Amendments to the Drawings:

REMARKS/ARGUMENTS

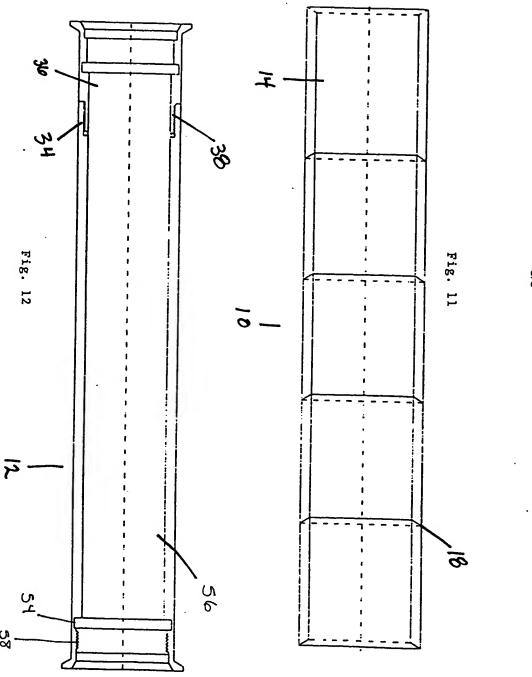
The attached sheet of drawings includes changes to Fig. 12. This sheet, which includes Fig. 12, replaces the original sheet including Fig. 12.

the application, and the information is to clarify and add numbers to Fig. 12, right side which are in the

specification. These numbers should have appeared on Fig. 12 to show a close fit and locking or

compression ring. The section which matches the replacement Fig. 12 reads "In another embodiment

(see Fig. 12, right end), rotary target segments 54 are slid onto the backing tube 56. The segment 54

abuts against a step or rim on the backing tube 56. After the last segment 54 is placed upon backing

tube 56, a compression fitting 58 is disposed on the opposite end of the backing tube 56, thereby

securing the target segments 54 upon the backing tube 56."
